M. J. N. PRIESTLEY AND M. J. STOCKWELL.

"A CONSIDERATION OF P-DELTA EFFECTS IN DUCTILE REINFORCED CONCRETE FRAMES" - T. Paulay.

Bulletin of N.Z. National Society for Earthquake Engineering, Vol. 11, No. 3 September, 1979.

FIGURE A: ABSOLUTE ACCELERATION RESPONSE SPECTRUM BUCAREST (INCERC), 3/4/77. 2122 GMT, S-N 0.2.5.10.20 PERCENT CRITICAL DAMPING SEISMIC ENGINEERING BRANCH/USGS

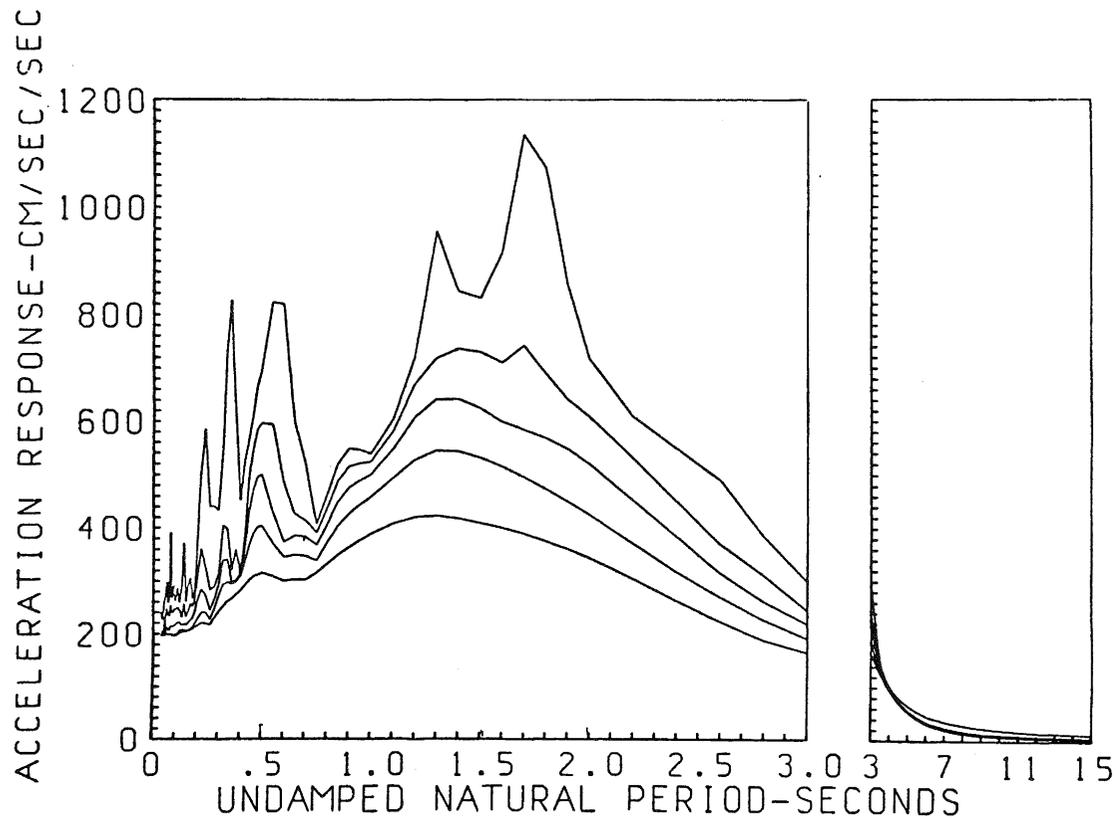
We regret that the Bucharest 2% damping response spectrum shown in Fig. 9 was a crude approximation based on an early analysis of the accelerogram. Since writing the paper the more accurate corrected spectra have become

available from the U.S. Geological Survey at Menlo Park^(B). The response spectra from this source for 0-20% damping are shown in Fig. A for the Bucharest 1977 S - N component used in our analyses. It is significant that the improved performance claimed by Mr. McKenzie for a 2.0 sec. period structure is not apparent in Fig. A. Even for 10% equivalent viscous damping (which is rather more than could be expected for the damped system), peak response at 2.0 sec. is expected to be 0.45 g, using the approach adopted by Mr. McKenzie ignoring damper stiffness. The structure ductility would then be expected to be in the vicinity of 2.0. However, since approximately 90% of the structure yield displacement is provided by bearing displacement, while all the inelastic displacement will now be provided by pier plastic displacements, the curvature ductility corresponding to the structure ductility of 2.0 will be very high (about 20 in this case, depending on the estimated plastic hinge length). This behaviour is illustrated in Fig. B. Clearly under 1.5 x Bucharest, the curvature ductilities will be much greater (approximately doubled).
